## ADDENDUM NO. 1

TO: PLANS AND SPECIFICATIONS FOR STATE OF MISSOURI

Replace Steam, Water & Sewer Lines, Bldg. 3  
Maryville Treatment Center  
Maryville, Missouri  
PROJECT NO.: C1921-01

APPENDIX F PHOTOS

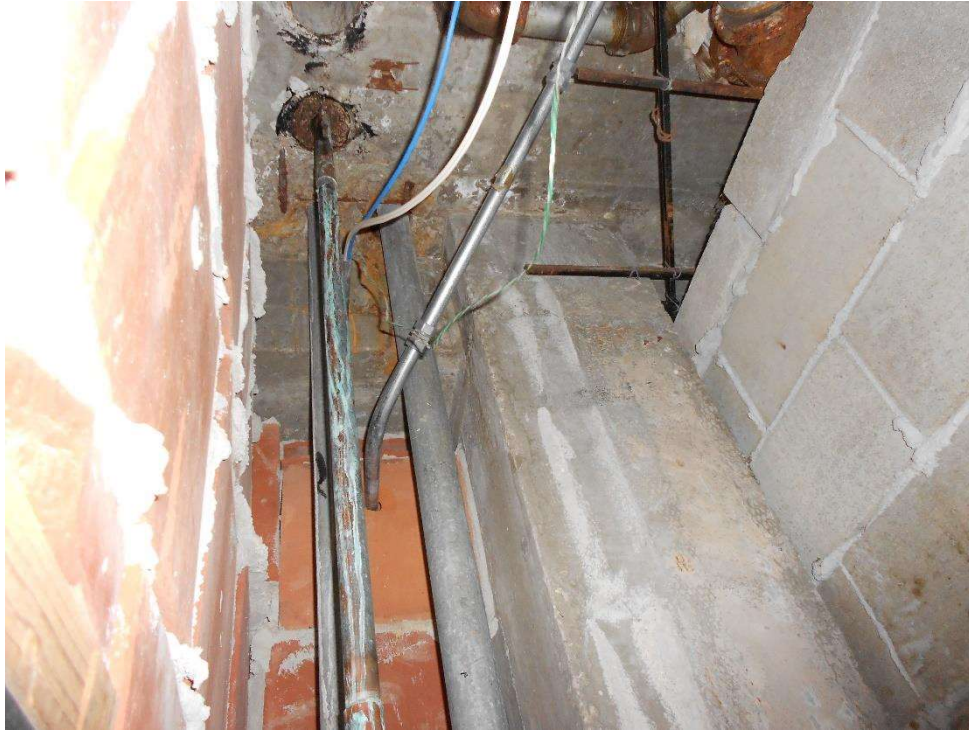
5. Appendix F – Asbestos Containing Building Material (ACBM) Schedules

- a. ADD Appendix F Photos (see attachment).
